**TO:** WECC ATSM ADHOC GROUP  
**FROM:** POUYAN POURBEIK, PEACE®; [PPOURBEIK@PEACE-PLLC.COM](mailto:PPOURBEIK@PEACE-PLLC.COM)  
**SUBJECT:** PROPOSED CHANGES TO VHVDC1 FOR CREATING VHVDC2  
**DATE:** 4/17/23 (REVISED 5/10/23; 8/23/24)  
**CC:** P. MITRA, EPRI

On 4/11/23 the group had a webcast/conference call to discuss the comments kindly shared by Raul Perez of NextEra Energy on 3/6/23, from their consultant Mitsubishi Electric Power Products, Inc. (MEPPI) Power Systems Engineering Division (PSED), on the vhvdc1 generic model. They (MEPPI) have compared the vhvdc1 model to a user-written model for the NextEra's Transbay Cable HVDC link. They thus came back with a number of recommendations.

**Figure 1:** Proposed changes to include a remote bus point of measurement and control.

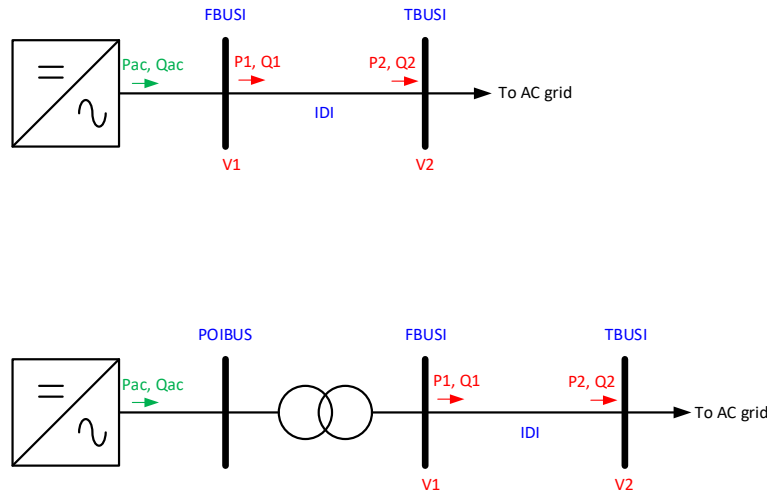
**Recommendation 1** – The key recommendation here was to allow for a remote bus in the power flow to be the point of measurement and control for each of the two converter stations. Thus, the decision was to introduce six (6) more parameters in the dynamic model, as follows:

The approach would be identical on both sides. Figure 1 below helps to explain the approach on the inverter side, with the rectifier side being the same.

As shown in Figure 1, one of two approaches can be taken. One to implicitly include the converter transformer in the loss calculations in the converter power flow model. Secondly, to explicitly model the converter transformer in power flow. It is extremely important to note that either way, the path from the converter to the most remote bus (TBUSI) must be completely radial. **Important Note:** A simple way that this can be checked in each software tool is that if  $P1$  (or  $P2$ )  $< 0.95 \times Pac$  then a warning message should be given to the user “*WARNING! Measured AC Power is significantly less than AC power coming out of the converter at bus XX, ensure that defined branch is radial to converter?*”. Also, if the defined branch is ill-defined (i.e., a nonexistent branch) then  $Pac$ ,  $Qac$  and  $Vac$  at the POI of the converter is used, and a warning message given to the user to this effect.

- $P$  and  $Q$  are always calculated in the direction of  $FBUSI \rightarrow TBUSI$

- P1, Q1 and V1 are the measured values used in the model for P, Q and V ac control if TBUSI is a positive number
- P2, Q2 and V2 are the measured values used in the model for P, Q and V ac control if TBUSI is a negative number. (Note: the idea here is that when TBUSI is entered as a negative number, then clearly |TBUSI| is what is used in monitoring the branch, but the -ve sign indicates that the measurements are to be made on the TO end of the branch. Alternatively, an extra model parameter could be defined to indicate whether the FROM or TO end measurement points are to be used).

**Figure 2:** Proposed changes to the controller parts of the *vhvdc1* model.

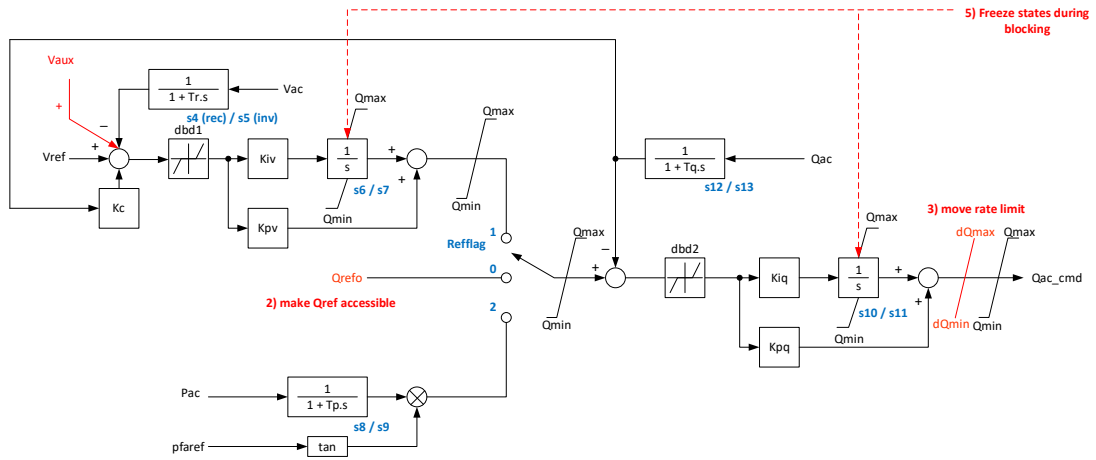
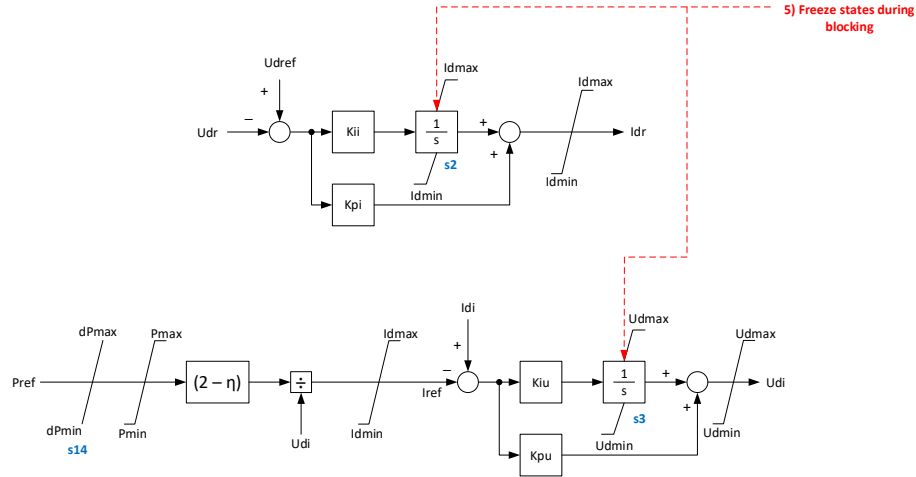
**Recommendation 2** – Add user access to **Qrefo** (see Figure 2 below). As an aside two other items were also discussed. First, to also add **Vaux** as an additional input accessible by the user. Secondly, to add another parameter to the dynamic model:

**Recommendation 3** – Move the ramp rate in the Q/V controls to the new location show in Figure 2 below. The software vendors indicated that they would implement this ramp rate as a numerically solved rate, rather than introducing a new state in the model with a very small time-constant.

**Recommendation 5** – for each converter’s controls, freeze all the states when the converter is blocked – see Figure 2. Note: this means that each converter has its own independent blocking.

**Figure 3:** Proposed V vs P lookup curve for determining the blocking voltage at the inverter/rectifier end as a function of active power (MW) transfer. The idea is to have two (2) sets of four (4) pairs of numbers one for the inverter end and one for the rectifier end.

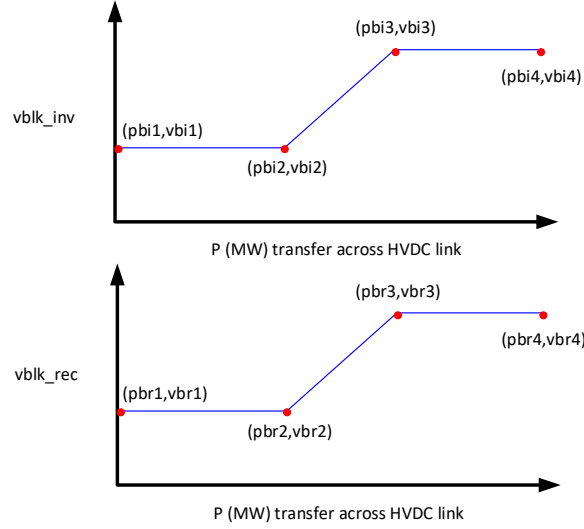
**Recommendation 4** – Add new parameters to define a look-up table for changing the blocking voltage at the inverter/rectifier as a function of active power (MW) being transferred by the HVDC link (see Figure 3).

Thus, *vblk\_inv* and *vblk\_rec* are removed as user input parameters from the dynamic model, and instead we introduce two (2) sets of four (4) pairs of parameters, i.e.

- The power points must be monotonic, i.e.,  $1 \geq pbi4 > pbi3 > pbi2 > pbi1 \geq 0$
- If  $pbi4 < 1$ , then  $vblk\_inv = vbi4$  for all power levels above  $pbi4$
- If  $pbi1 > 0$ , then  $vblk\_inv = vbi1$  for all power levels below  $pbi1$ , down to 0 pu power
- The above three points clearly apply similarly to the rectifier side parameters too.
- The voltage here refers to the voltage at the AC bus which is the point of measurement (POM) for the converter. That is, each converter side will block independently when the filtered Vac at the POM (e.g., voltage at V1 or V2, see recommendation 1) falls below the *vblk* coming out of this function.
- The value of P used on the x-axis of the four (4) point piecewise linear curves is the initial DC power transfer across the HVDC link upon model initialization.
